EMF-1961 (NP)(A)  
Revision 0

# Statistical Setpoint/Transient Methodology for Combustion Engineering Type Reactors

**SUBJECT: ACCEPTANCE FOR REFERENCING OF LICENSING TOPICAL REPORT  
EMF-1961(P), REVISION 0, "STATISTICAL SETPOINT/TRANSIENT  
METHODOLOGY FOR COMBUSTION ENGINEERING TYPE REACTORS"  
(TAC NO. MA4659)**

**Figure 2.1 Flow of LPD LSSS or LCO Confirmation**

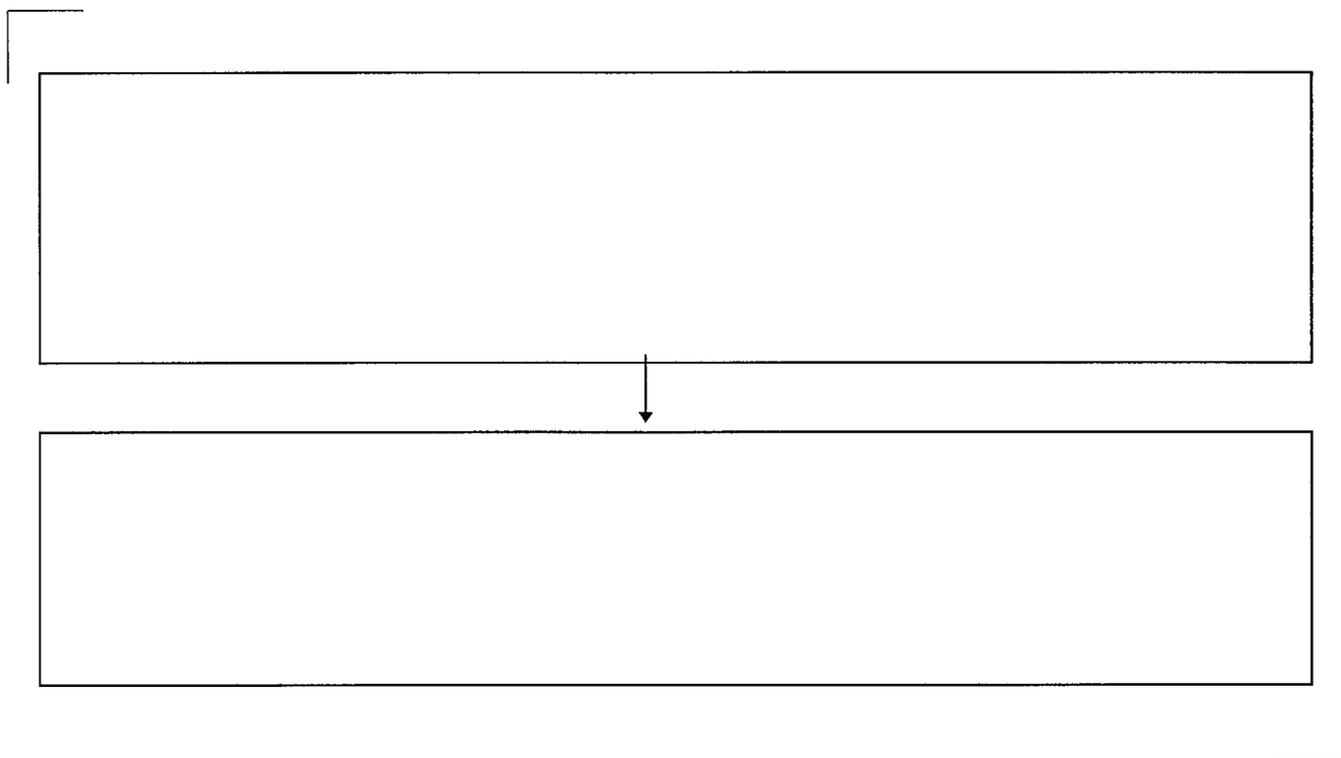
1. Please provide flowcharts of overall methodology for arriving at the statistical setpoint/transient analysis.
2. Please confirm the use of textbook statistical methods throughout.
3. Please explain if the applied methodology is in accordance with the methodology described in GSUAM.
4. Please provide details on why the methodologies for the two reactor types differs.

Figure 2.1 shows the flow of the process for confirming the LPD LSSS. To confirm the LPD LSSS, a series of calculations is performed using each axial power shape. Those shapes for which the melt power exceeds the power at which the shape was

Figure 2.2 Flow of TM/LP Confirmation

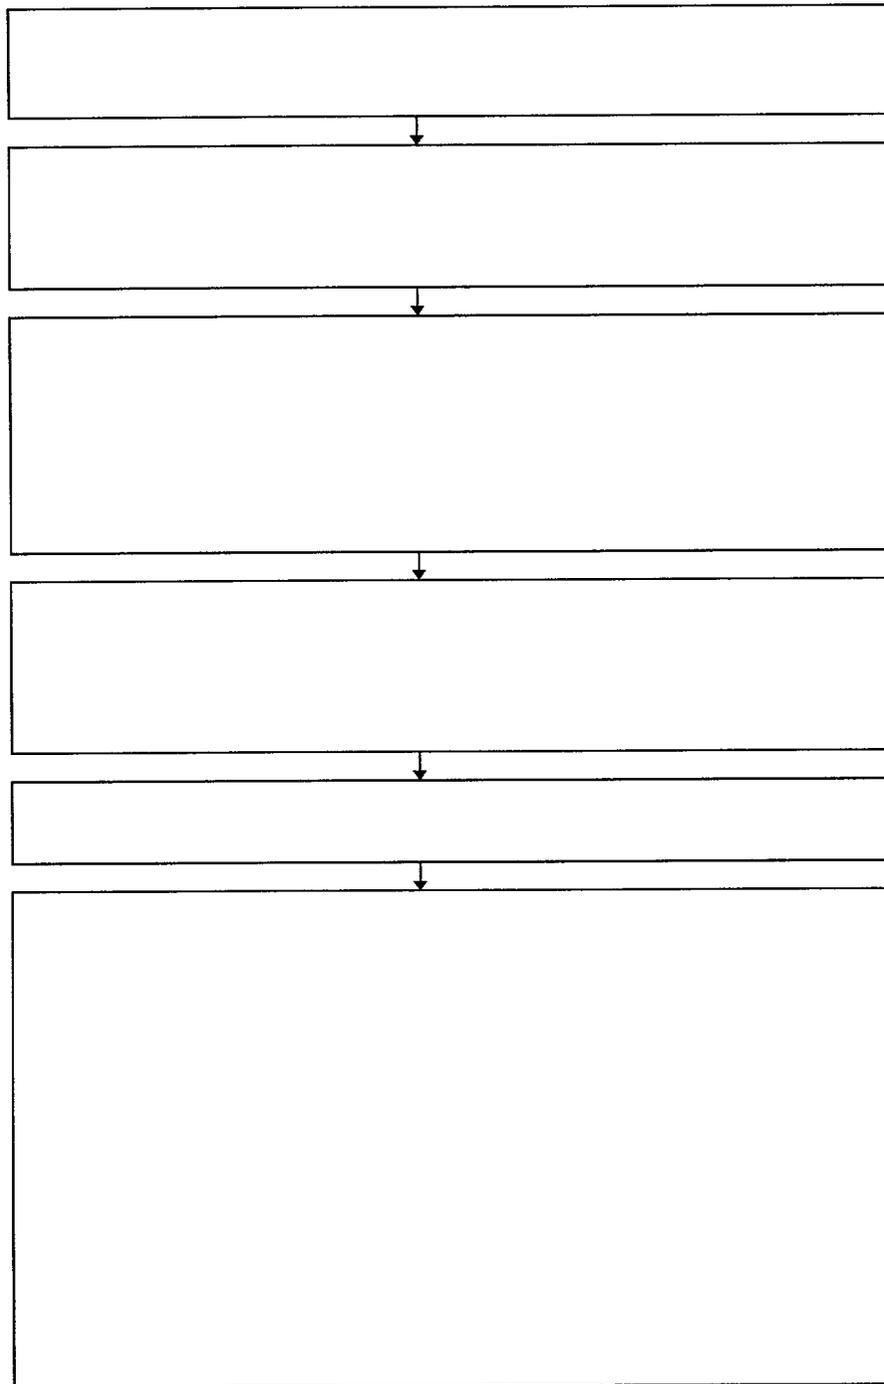
The general form of the TM/LP trip is given. Please detail how the alpha, beta, and gamma terms for the equation were determined.

The iterative scheme for obtaining the DNB portion of the  $P_{VAR}$  is described. Please provide additional details or a demonstration of this iterative scheme.

The coefficients for the TM/LP trip;  $\alpha$ ,  $\beta$  and  $\gamma$ ; are determined such that they prevent the occurrence of hot leg saturation or DNB. The traditional method of determining the values makes use of the Core Safety Limit Lines (CSLLs) and finds a set that conservatively bounds the CSLLs. When a confirmation of the trip is performed, the values selected for the trip are checked to confirm that they provide the protection for DNB and hot leg saturation. Whether SPC created the values from the CSLLs or modified existing values in some way, the ultimate test of the acceptability of the values is the confirmation process.

] The iterative process is repeated for a range of values in power and  $T_{inlet}$  that cover the range over which the TM/LP would need to provide protection. In addition to the power and  $T_{inlet}$ , the axial power shape is considered as a variable, too. These three inputs are varied because they represent the parameters that are input to the TM/LP.

**Figure 2.3 Flow of DNB LCO Confirmation**

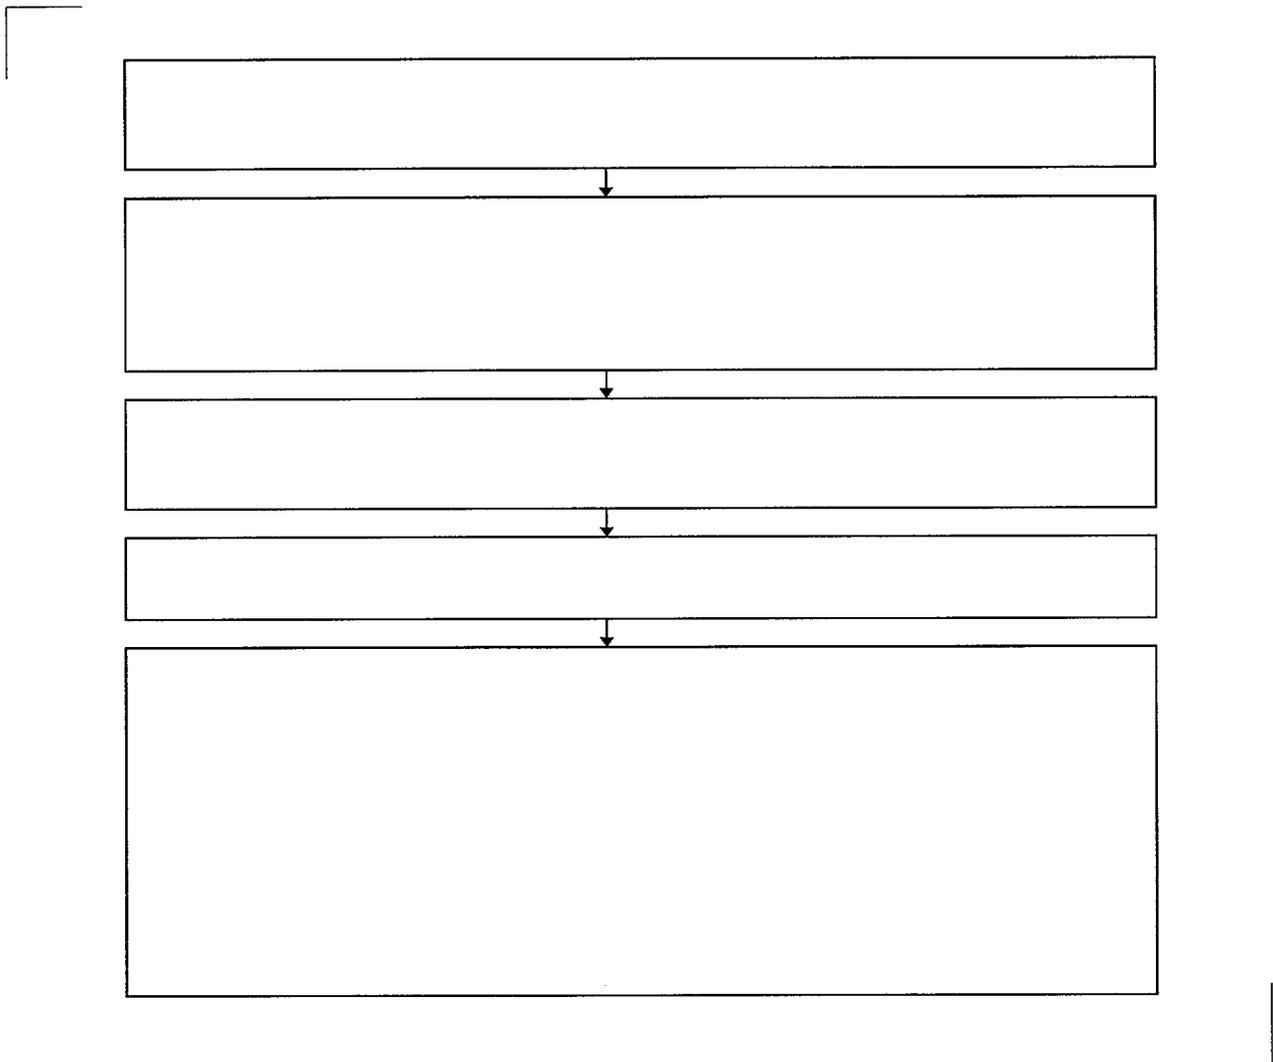
Please provide additional details or demonstrate how the LOCF confirmation is performed.

] XCOBRA-IIIC is then used to calculate the response surface points. Using the nominal points from XCOBRA-IIIC and the response surface points, the margin between the initial power corresponding to DNB (a statistical variable) and the DNB LCO is calculated for each nominal point.
